Enclosure 2

Revised CCNPP Unit 3 FSAR Section 2.5.2.6

Enclosure 3

Revised CCNPP Unit 3 FSAR Section 3.7

Figure 2.5-241 — {Site SSE Comparison with Adjusted FIRS and RG 1.60 - NI Common Basemat Structures}

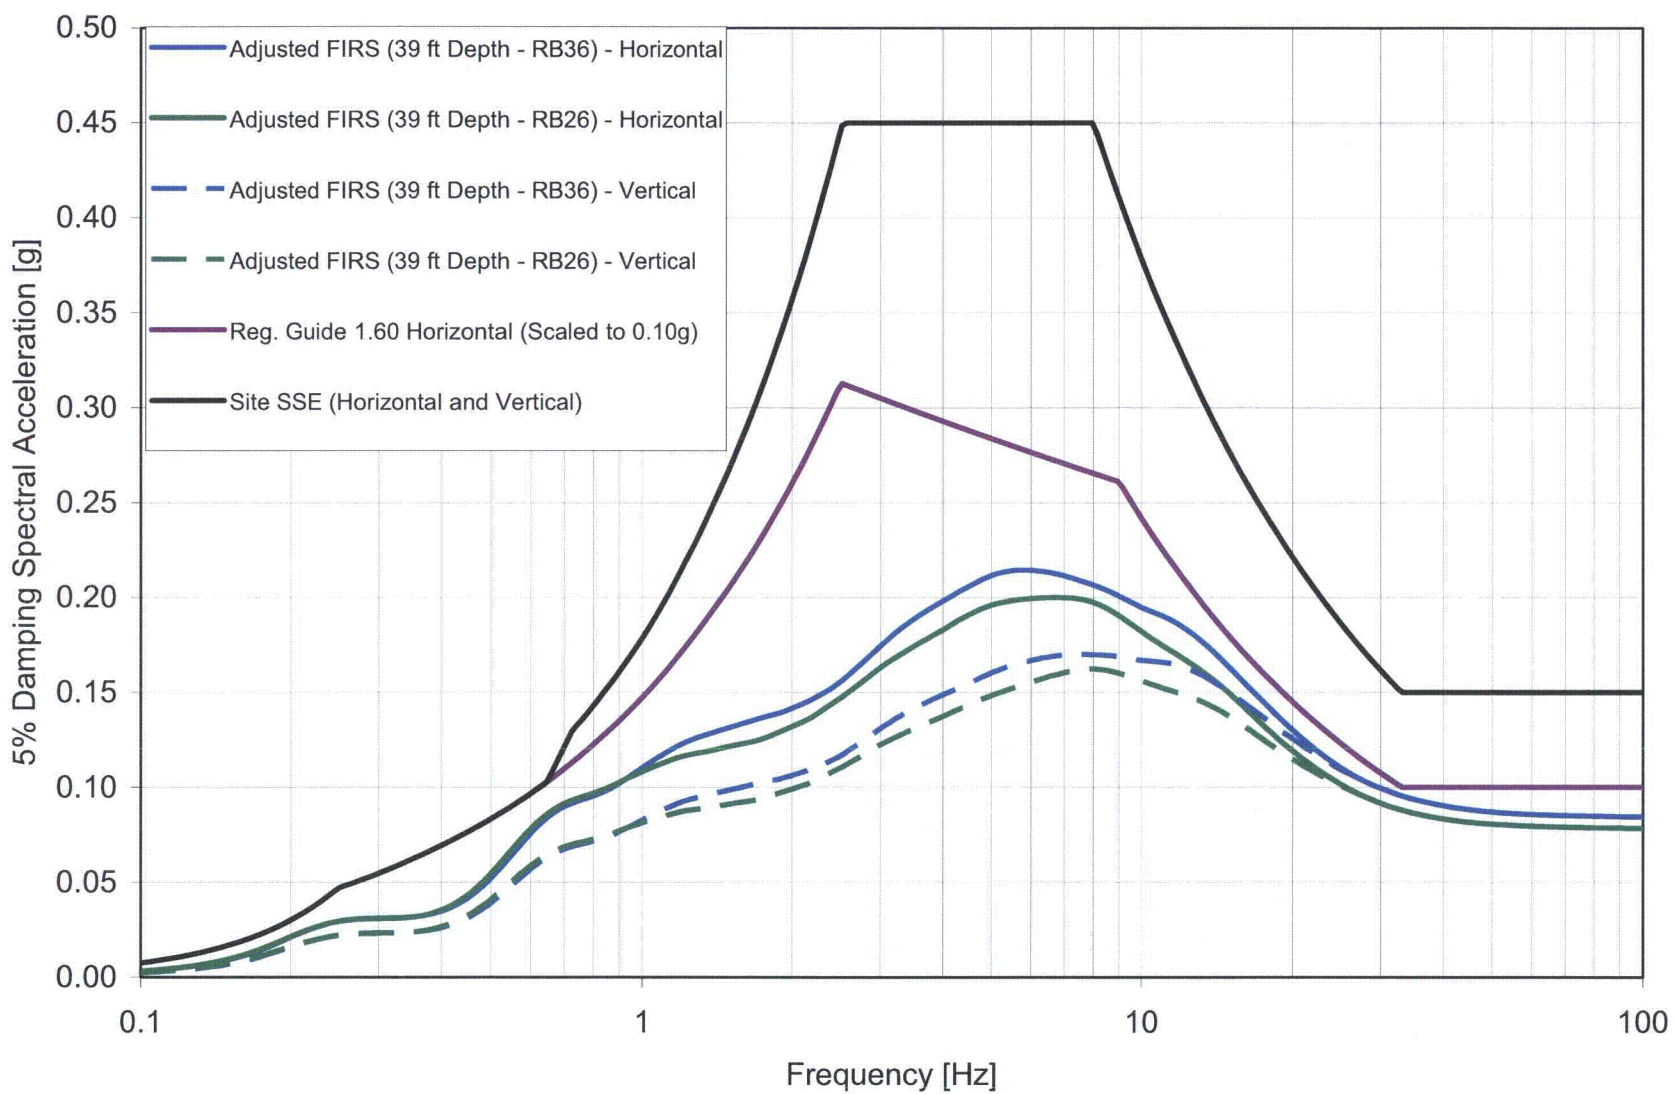
CCNPP3 Response: Figures 3.7-2 and Figure 3.7-3 show comparisons of the FIRS to the site SSE for the NI Common Basemat Structures, without considering the NI backfill. Figure 2.5-241 shows a comparison of the CCNPP3 FIRS to the site SSE for the NI Common Basemat Structures, considering backfill. These figures show that the FIRS are bounded by the site SSE as well as the Regulatory Guide 1.60 spectra. Figure 3.7-6 shows a comparison of the site SSE, which is used as input to the confirmatory analysis, with the CSDRS. For most frequencies, the SSE is bounded by the CSDRS by a factor of 2.

Two sets of NI FIRS are shown on Figure 2.5-241 to account for the varying depth of backfill between the planned excavation and the varying bottom contour of the NI basemat. The two sets of strain-compatible SWV's associated with the CCNPP3 SSE response spectra are shown in Figures 2.5-242 and 2.5-243 for the upper 200 feet of the soil. Tables 2.5-76 and 2.5-77 show the strain-compatible values for the entire soil depth.

Figure 3.7-6— {CCNPP Unit 3 Site SSE, Site OBE and EUR CSDRS}

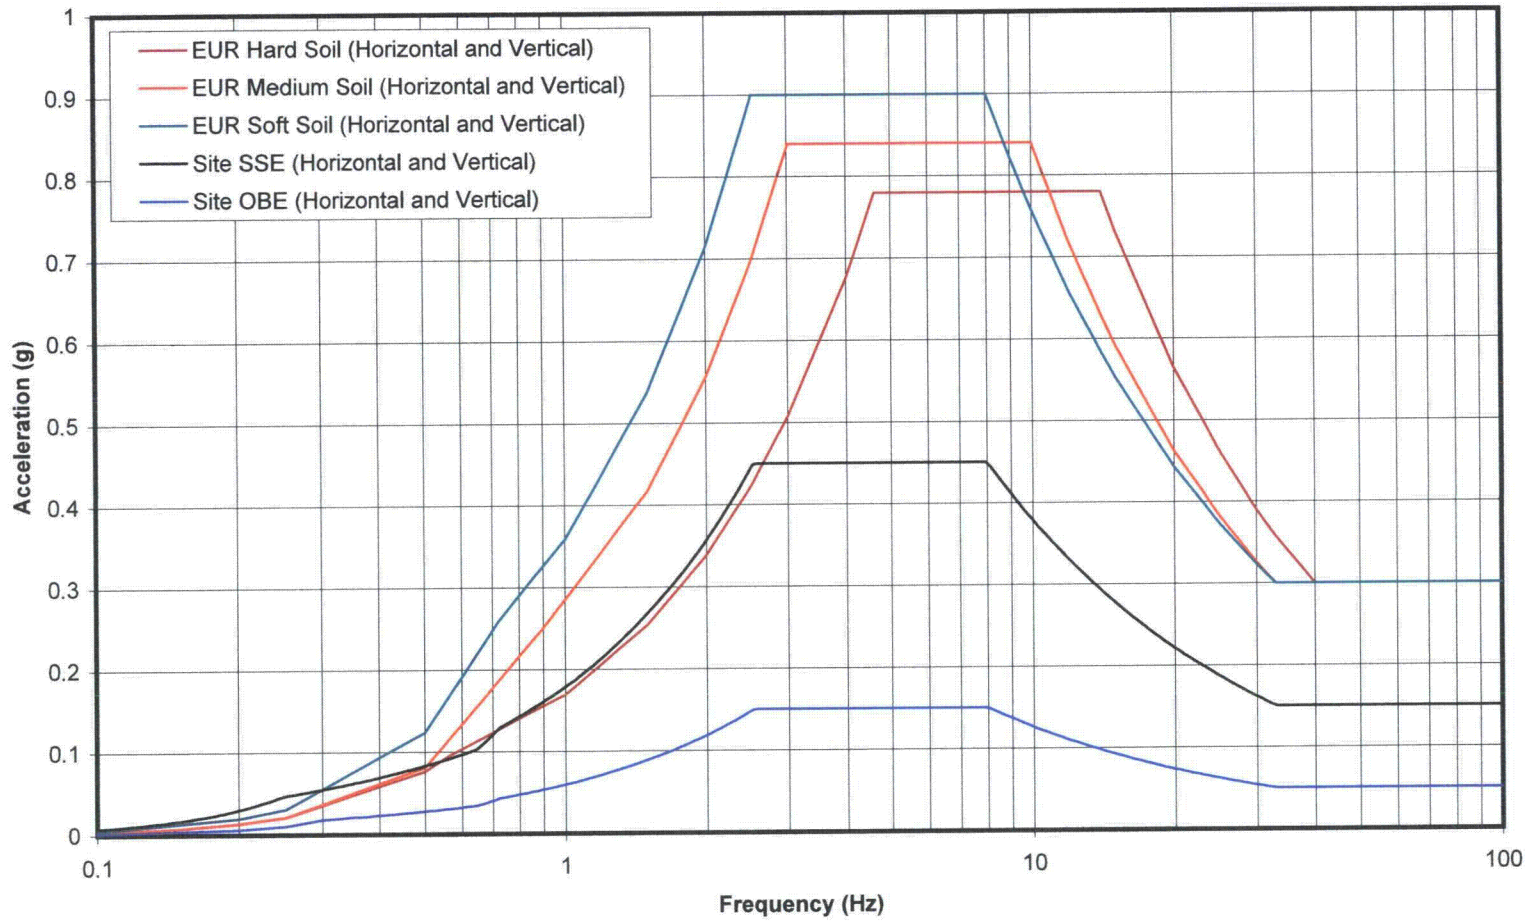
The EUR soft soil spectrum is lower than the Site SSE below approximately 0.36 Hz. Therefore, the Site OBE for CCNPP Unit 3 is the composite earthquake which consists of one-third of the site SSE (i.e. the Site SSE anchored at 0.05g vs. 0.15g) in the high frequency, and one-third of the EUR Soft Soil spectrum (i.e. the EUR Soft Soil Spectrum anchored at 0.10g vs. 0.30g) in the low frequency (approximately 0.36Hz and below). The Site OBE is shown in Figure 3.7-6.

- ◇ the U.S. EPR FSAR certified seismic design response spectra (CSDRS) does not envelop the Site SSE in the low frequency range, as shown in Figure 3.7-6, and
- ◇ the site-specific strain-compatible best estimate (BE), lower bound (LB) and upper bound (UB) soil profiles are bounded, but exhibit variations in the upper layers when compared with the ten generic soil profiles used in U.S. EPR FSAR, as described in FSAR Section 3.7.1.3.1.

Figure 3.7-19— {CCNPP Unit 3 Strain-Compatible Soil Profiles for NI Common Basemat Structures}

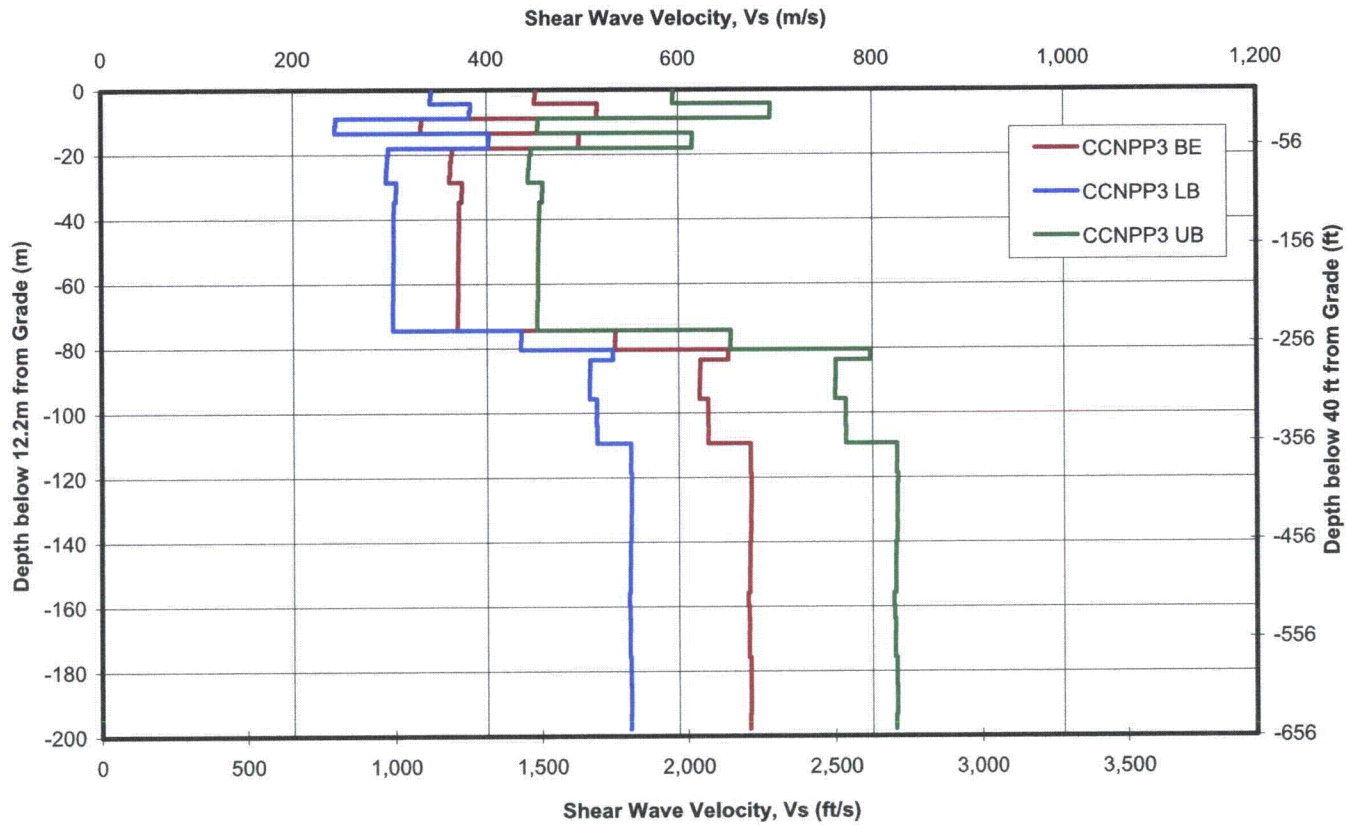
The supporting media for the seismic analysis of the NI Common Basemat Structures is shown in Figure 3.7-19 and Table 3.7-2 through Table 3.7-4. The presented soil profiles are site-specific and are strain-compatible with the Site SSE. Lower bound and upper bound profiles are calculated maintaining a minimum variation of 0.5 on the shear modulus. An evaluation of the CCNPP Unit 3 site-specific soil profiles with respect to the criteria provided in U.S. EPR FSAR Section 2.5.2.6 is described below in Section 2.5.2.6.

Note that in contrast to Figure 3.7-19, where the top layer is located at the bottom of the NI common basemat foundation at approximately 40 ft (12 m) below grade, Figure 3.7-21 presents the profiles for the upper 656 ft (200m) with the top layer at grade, including the structural backfill layers, therefore consistent with the confirmatory SSI analyses of the EPGB and ESWB, described in Section 3.7.2.

Figure 3.7-21 — {CCNPP Unit 3 Strain-Compatible profiles at the NI Area for EPGb and ESWB}

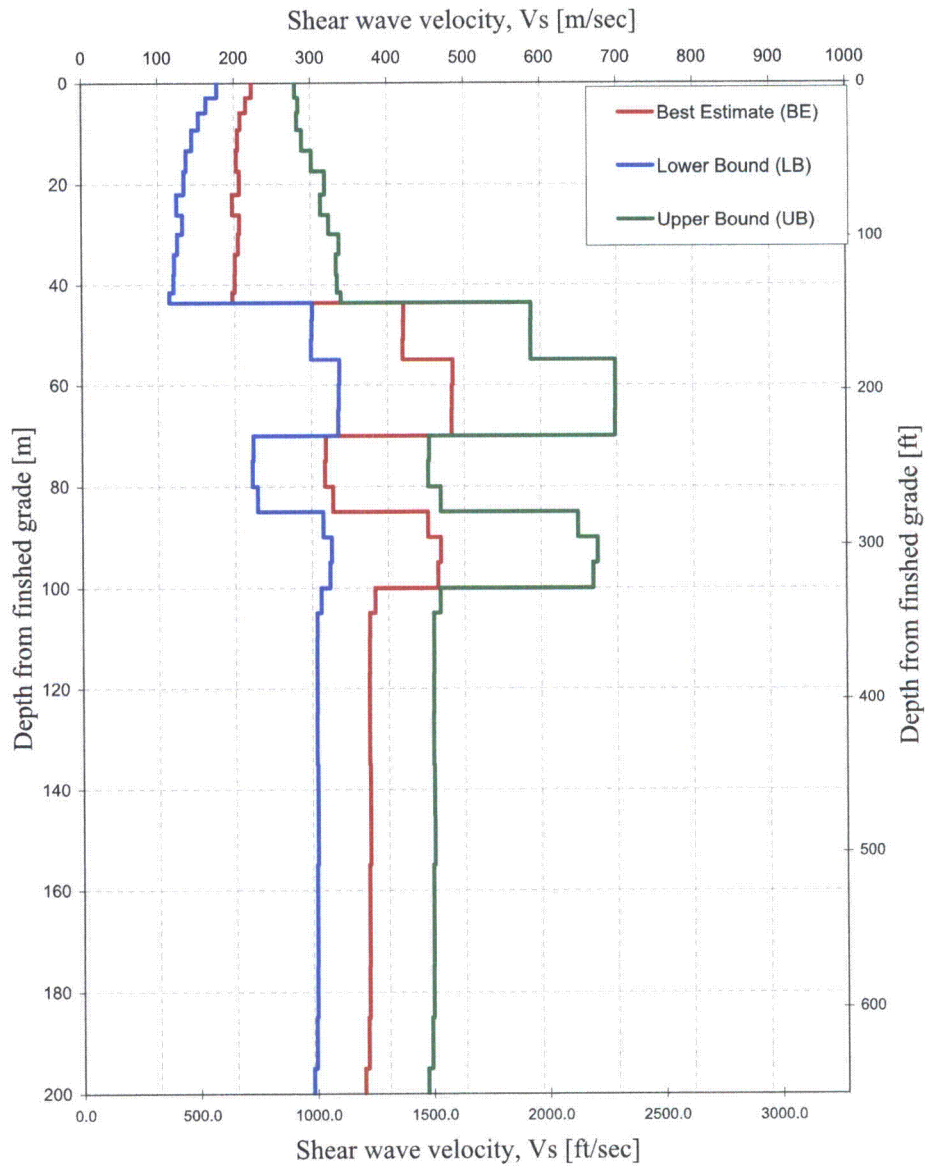
The supporting media for the seismic analysis of the EPGB and ESWB in the NI area are presented in Figure 3.7-21. The presented soil profiles are site-specific and are strain-compatible with the Site SSE. The development of the Site SSE strain-compatible soil profiles is described in detail in Appendix 3F.

Figure 3.7-22— {CCNPP Unit 3 Strain-Compatible profiles at the Intake Area for CBIS}

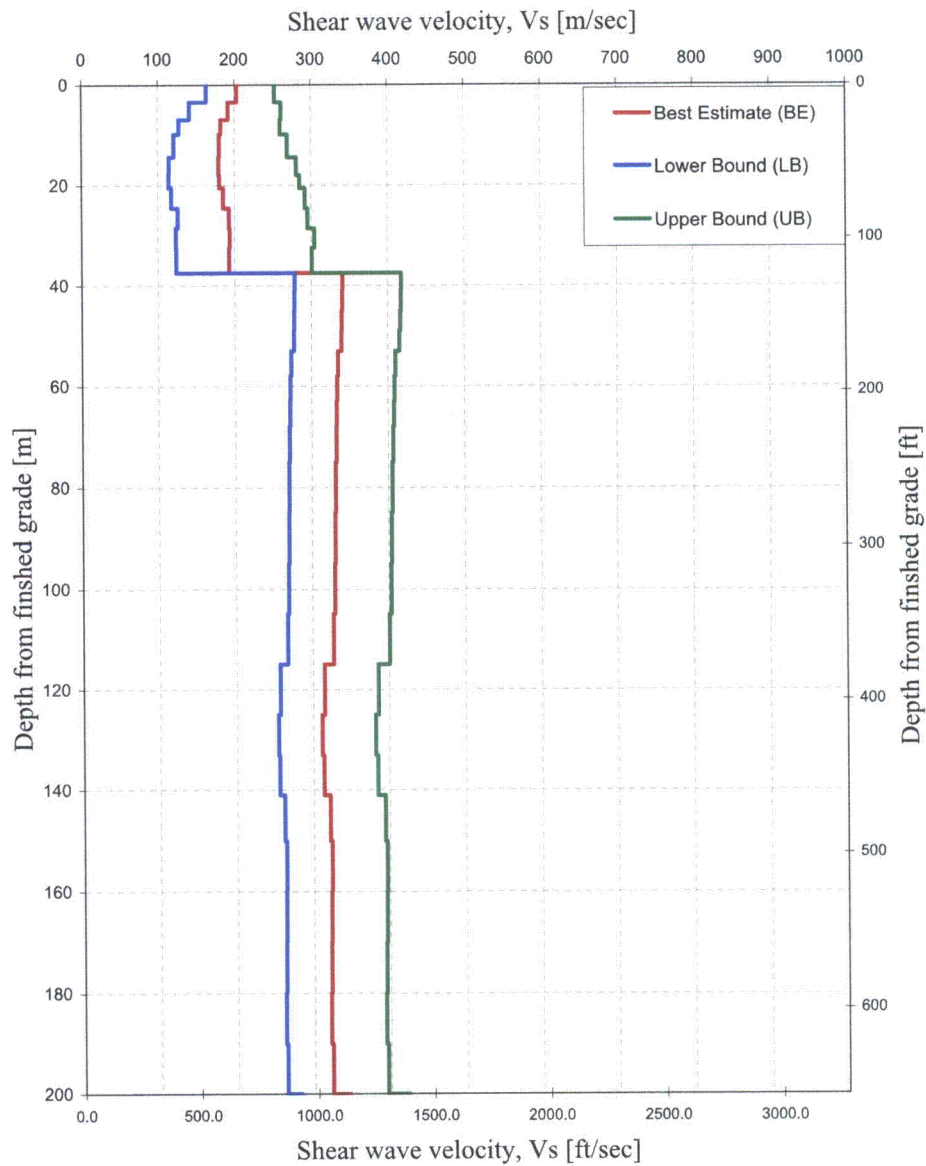
The supporting media for the seismic analysis of the CBIS in the Intake area are presented in Figure 3.7-22 for the upper 656 ft (200m). The presented soil profiles are site-specific and are strain-compatible with the Site SSE. The development of the Site SSE strain-compatible soil profiles is described in detail in Appendix 3F. The dimensions of the CBIS, including the structural height, are described in Section 3.7.2.3.2.

Figure 3.7-23— {Isometric View of the Common Basemat Intake Structures}

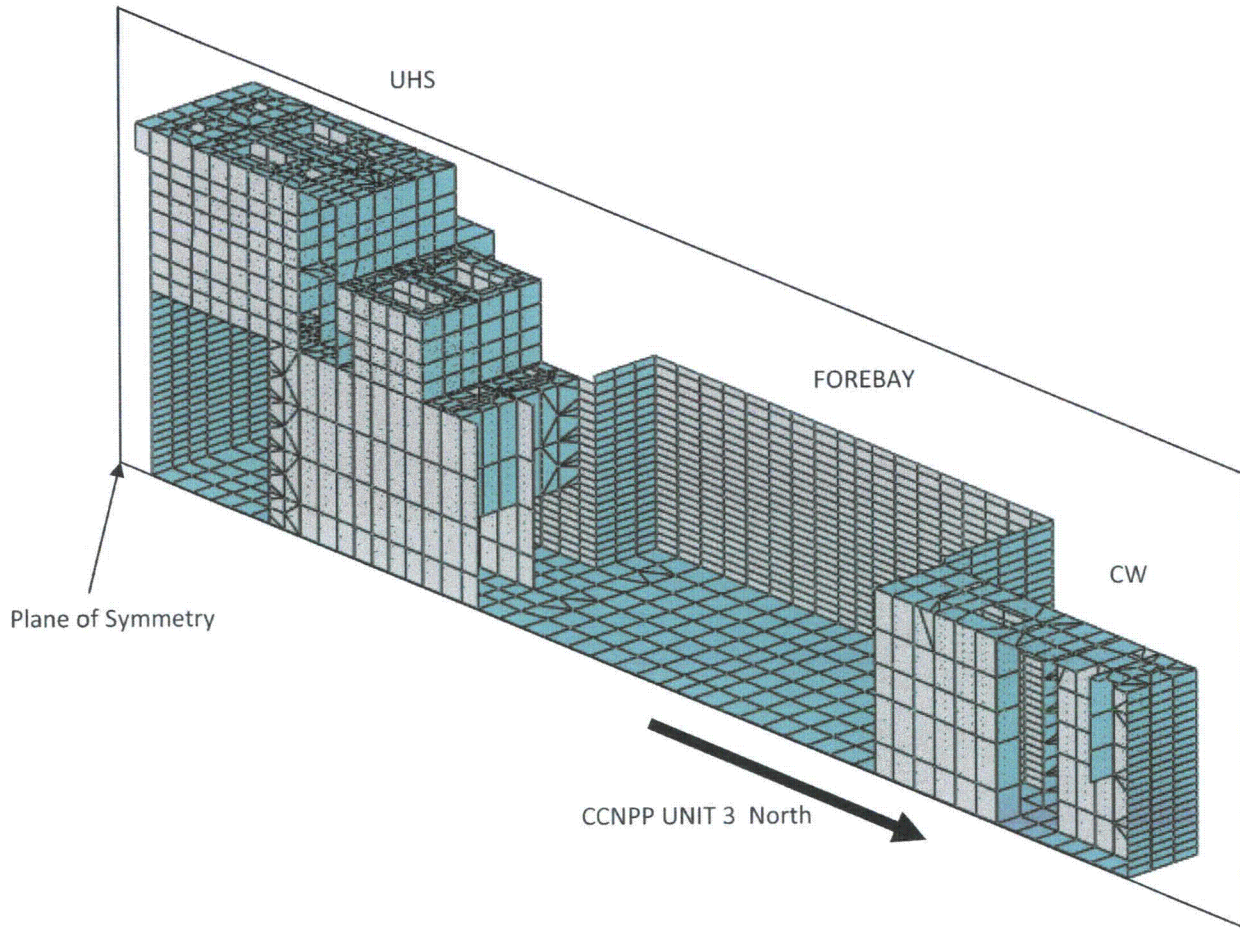
The CBIS are symmetric about the North-South axis, as depicted in Figures 9.2-4 through 9.2-6 and 10.4-4 and 10.4-5. A sensitivity analysis was performed to consider the effects of the non-symmetric features such as door openings and equipment masses. Based on the sensitivity analysis, only one-half (western half) of the CBIS is modeled for the SSI analysis. Figure 3.7-23 depicts the finite element mesh for the half model.

causes anti-symmetric loading on the structure. The seismic SSI analysis is performed by applying appropriate symmetric and anti-symmetric boundary conditions in the plane of symmetry of the half model shown in Figure 3.7-23, as indicated in Table 3.7-7.

Figure 3.7-24— {Soil-Structure Interaction (SSI) model for the Common Basemat Intake Structures (Elevations and plant coordinate system refer to CCNPP Unit 3)}

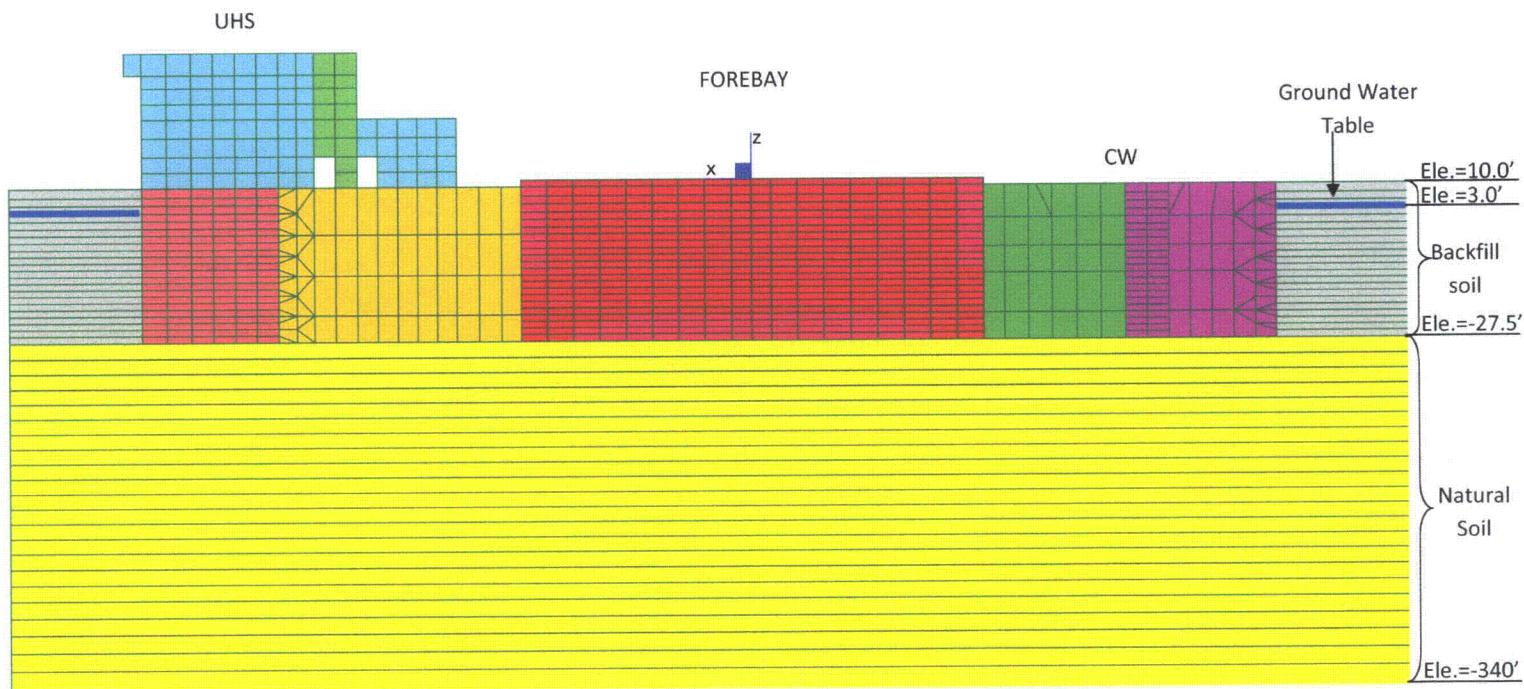
The SSI model includes the CBIS, the surrounding layers of structural fill and the existing soil media as shown in Figure 3.7-24. Interaction forces are obtained at the basemat nodes at the soil-structure interface, and subsequently used in the stability analyses described in Section 3.7.2.14.2.
